Technical Service BULLETIN

Title: **AUDIO SYSTEM MUTED AFTER ENDING BLUETOOTH WIRELESS PHONE CALL**

Models: '04 Land Cruiser

AUDIO
AU003-04

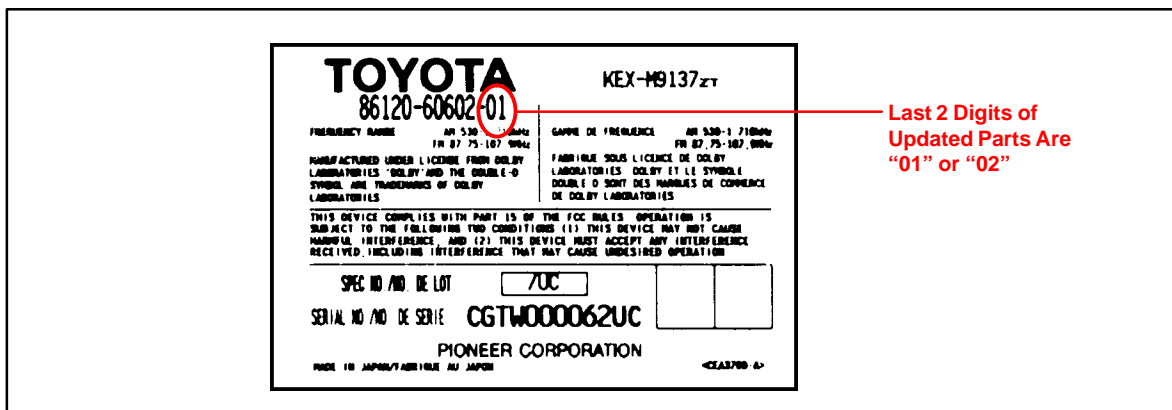
Introduction Some customers may experience no sound when turning on the audio system after ending a phone call using the Bluetooth system when the radio is off during the phone call. Improvements have been made to the software inside the audio head unit to remedy this condition.

- Applicable Vehicles**
- **2004** model year **Land Cruiser** vehicles equipped with the **Toyota Navigation System** produced **BEFORE** the Production Change Effective VIN shown below.

Parts Identification The updated parts will have a 2 digit number (01 or 02) after the Toyota part number on the tag on the bottom surface of the head unit.

Repair Procedure Order a replacement radio head unit from Pioneer through the exchange program by calling 1-800-553-3756.
